APPLICATION NO.	FILING DATE	FIRST NAMED INVENTOR	ATTORNEY DOCKET NO.	CONFIRMATION NO.
10/717,415	11/19/2003	Gunnar Behrens	HK-815	7259
24131	7590	11/27/2007	EXAMINER	
LERNER GREENBERG STEMER LLP			MORRISON, THOMAS A	
P O BOX 2480			ART UNIT	PAPER NUMBER
HOLLYWOOD, FL 33022-2480			3653	
MAIL DATE		DELIVERY MODE		
11/27/2007		PAPER

Office Action Summary	Application No.	Applicant(s)	
	10/717,415	BEHRENS ET AL.	
	Examiner	Art Unit	
	Thomas A. Morrison	3653

DETAILED ACTION

FIG.2

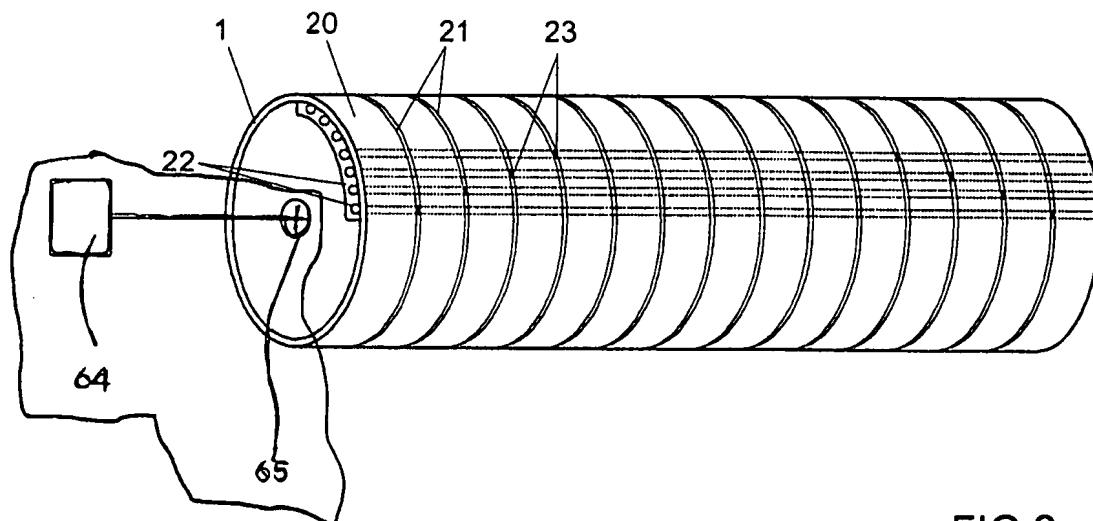
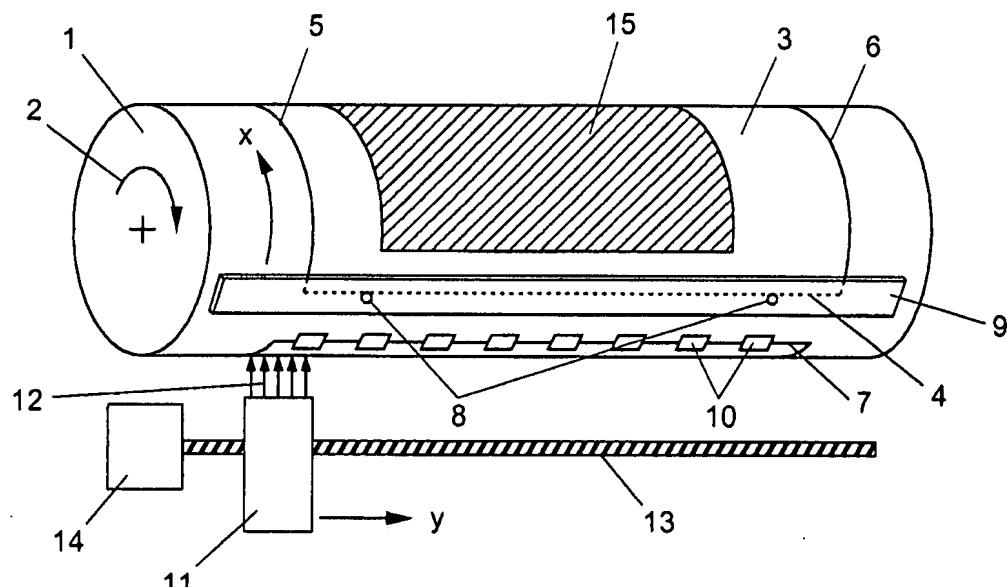
1. Applicant's amendments to the specification and claims filed on September 5, 2007 have been entered.
2. The drawing was received on 9/5/2007. This drawing (i.e., new Figure 2) has not been entered, because it introduces new matter. In particular, new Fig. 2 shows details of how a vacuum pump 64 is arranged and connected to an exposure drum 1, which is not supported by the disclosure of the instant application. Thus, the new drawing (i.e., Fig. 2) has not been entered.
3. This application is in condition for allowance except for the following formal matters:

4. The drawings are objected to under 37 CFR 1.83(a). The drawings must show every feature of the invention specified in the claims. Therefore, (1) the vacuum pump recited in claim 1 must be shown or the feature(s) canceled from the claim(s). No new matter should be entered.

Do not enter
11/25/07

One possible acceptable new Figure 2 would include (1) the recited vacuum pump of claim 1 shown as a **box labeled "64"**; (2) the rotary lead-through 65 of the specification shown as **another box labeled "65"**; (3) a line connecting the box labeled "64" to the box labeled "65"; and (4) a line connecting the box labeled "65" to the center of the exposure drum 1.
